## CHART STANDARDIZATION & PAPER CHART WORKING GROUP (CSPCWG)

### CSPCWG Letter: 13/2010

### **Subject: CSPCWG6 Actions 21-31 (except 24): follow-up to Letter 05/2010**

**CONSOLIDATED RESPONSES TO CSPCWG LETTER 05/2010**

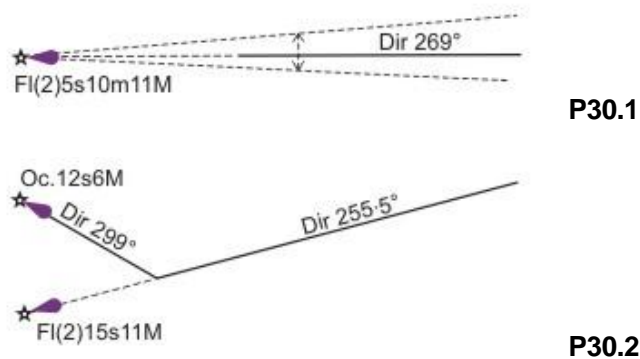
22. The heading for B-475.7 a. 'Unlit sectors or unintensified light' does not seem to describe this paragraph well.

We agree that read in isolation, this sub-heading does not seem to make sense. However, when read with the preamble in S-4 '...The narrow sector [singular] may be flanked by:', we believe it does. This is the case where there is really only a single narrow sector of light forming the directional lead, but because the sector is moving from side to side, it gives the appearance of changing characteristic at the outer limits.

B-475.7 b. second paragraph states 'The sector limits and arcs may, if considered useful, be charted...'. We would chart these sectors on a large scale chart, and not on a small scale chart. So the reason for the decision is really scale, because they are useful, and able to be charted without clutter, on a large scale chart. Perhaps change this sentence to:

'The sector limits and arcs may be charted instead of, or in addition to, the centre line if scale allows, as is the case for a sectored light.'

We agree to add 'if scale allows', but do not wish to detract from the meeting's decision that in most cases, to avoid chart clutter, it is better to just chart the centre line.

If it is considered appropriate to chart the sectors they should be labelled as:

Oc.R / F.R / Al.WR / F.W \ Al.WG \ F.G \ Oc.G

for a typical 7 sector oscillating light, with the legend DirWRG at the light star.
